DATE July 1, 2014
TO Jim Knott, Roadway Design Engineer
FROM Joel Rossman, Assistant State Bridge Engineer
THRU Mark Traynowicz, State Bridge Engineer
SUBJECT Niobrara East and West
Project No. S-12-5(1011), CN 31674
Bridge Engineering Review

This memorandum summarizes the results of a bridge engineering review of proposed bridges on the alternative alignments under consideration for the Niobrara East and West reconstruction project.

Subject: Summary Report of Proposed Slide Mitigation for Alternative B1
Niobrara East & West 12-5(1011), CN 31674

Figure 2. Standard Embankment Mitigation Methods

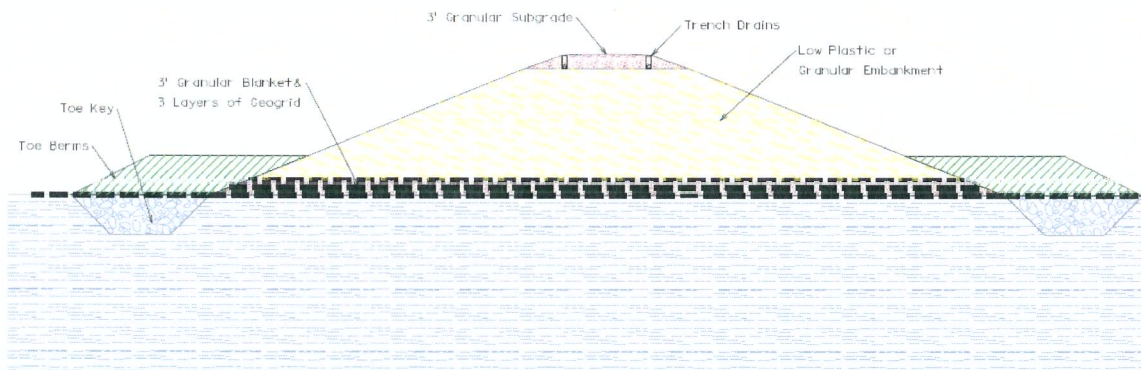
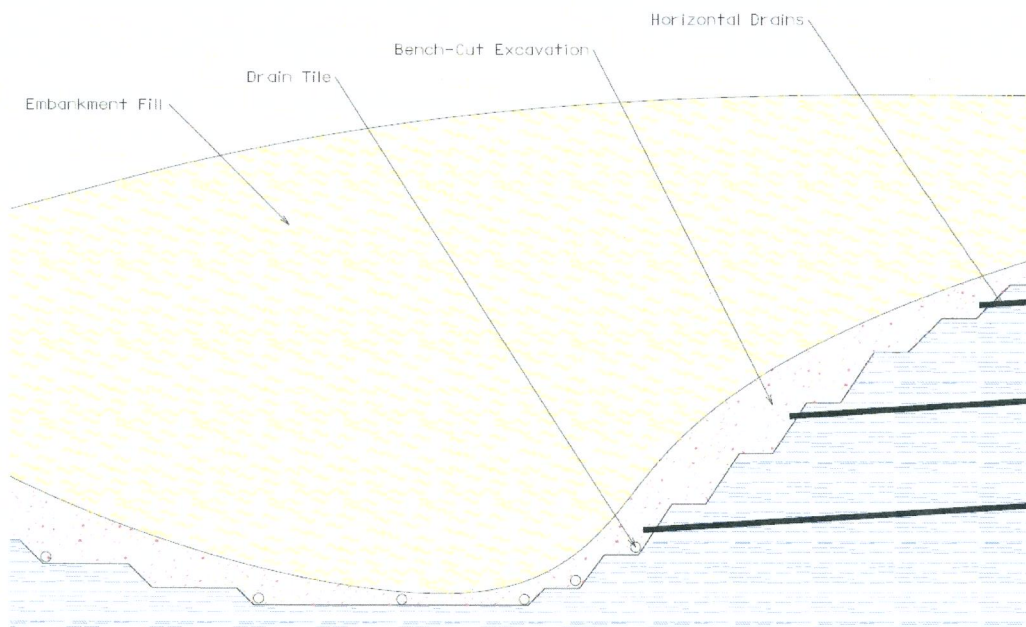
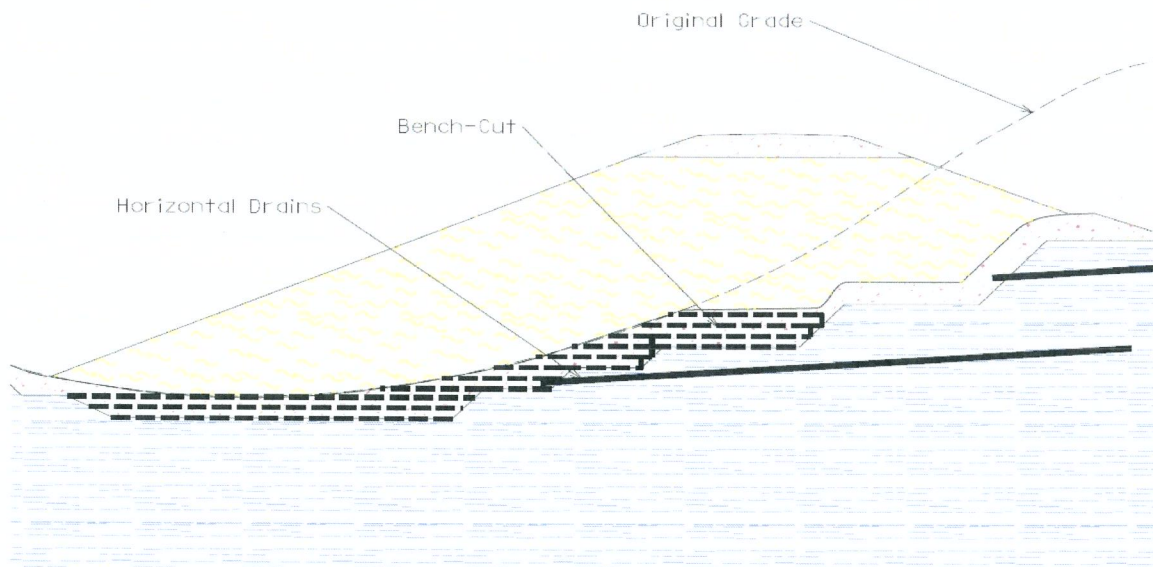
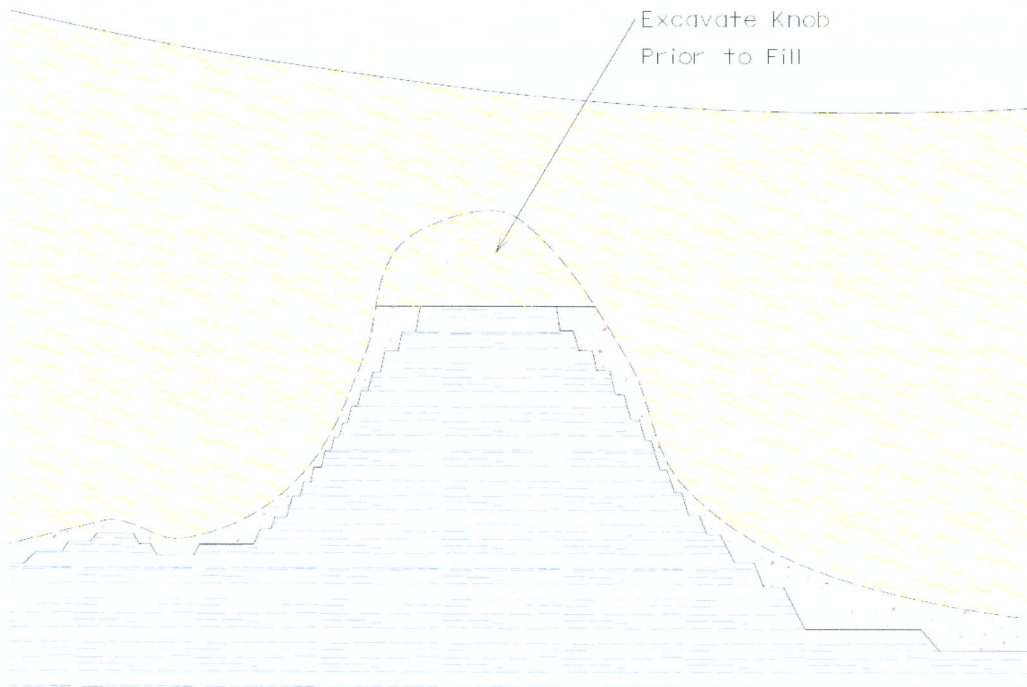
As in the cut-section, each fill-section should be evaluated on a case by case basis. The information provided are minimum recommendations based on observations in the field. Additional mitigation techniques may be warranted after a thorough drilling and testing program has been performed. Figures 2 through 5 show graphical presentations of the possible embankment mitigation measures.

- All slopes in fill-sections shall be constructed at 4H:1V.
- Embankment material shall consist of either low-plastic clay, silt, or granular materials.
- Following clearing and grubbing operations weathered shale areas and existing slides shall be removed through bench-cut excavations. Existing “knobs” of shale shall be cut horizontally prior to fill placement to minimize any slip-plane failures.
- A 3' granular blanket with 3 layers of high strength biaxial geogrid shall be placed as a base stabilization layer prior to placing embankment materials. The geogrid shall extend past the outside edge of the constructed toe-keys (see below)

- In sloped areas to receive fill, bench-cut excavations shall be made. Horizontal drains shall be installed in the same manner as described in the Cut-Slope mitigation section. A 3' thick granular blanket and 3 geogrid layers shall be placed within the bench-cut excavations to provide drainage and base reinforcement.

- At the toes of the embankment sections a toe-key shall be constructed to prevent deep-seated failures from within the shale underlying the embankment materials. The width and depth of the toe-key shall be based on embankment height and the engineering properties of the underlying shale. The toe-key shall be backfilled with a combination of rip-rap and granular materials and encapsulated with an impermeable geomembrane liner to prevent the migration of water into the toe-key excavation.
